INFORMATION BULLETIN NO. 110

TO: OWNERS OF J.H. FLETCHER & CO. MODEL DR AND CDR SINGLE MAST FEED ROOF DRILL ONLY

SUBJECT: MAST FEED CYLINDER GUARD

TITAN MAST GUARD

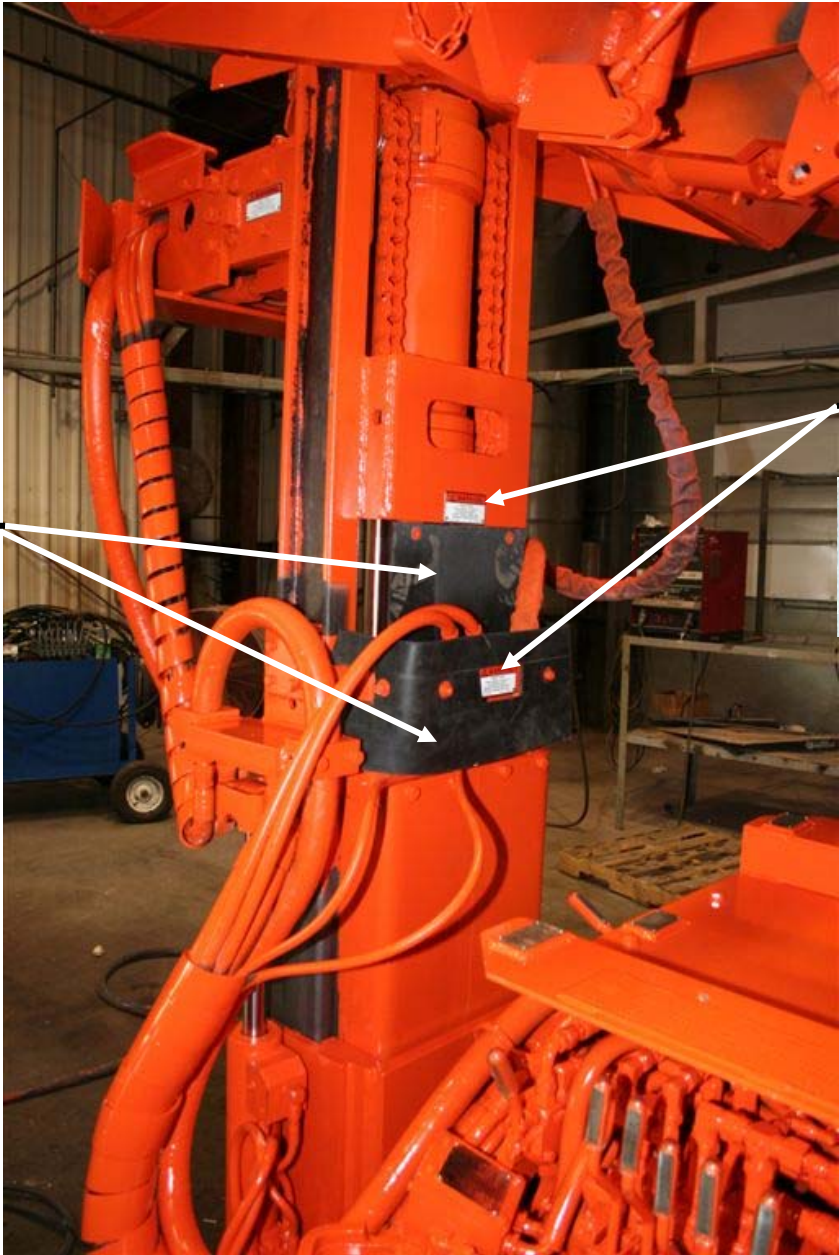
To discourage someone from placing a hand or body part in this position, J.H. Fletcher & Co. is providing all owners of DR and CDR roof drills with a new mast guard arrangement for this area.

1. Install the new guard kit (PN 415666) on the rear of the mast area as a reminder to avoid and to discourage operators from placing any body part on or in this pinch point. The guard and two warning tags (PN 359078) are being provided free of charge and must be installed in place of all existing (previously installed) guards in this area (see Attachment 2).

GUARD
KIT
PART NO.
415666
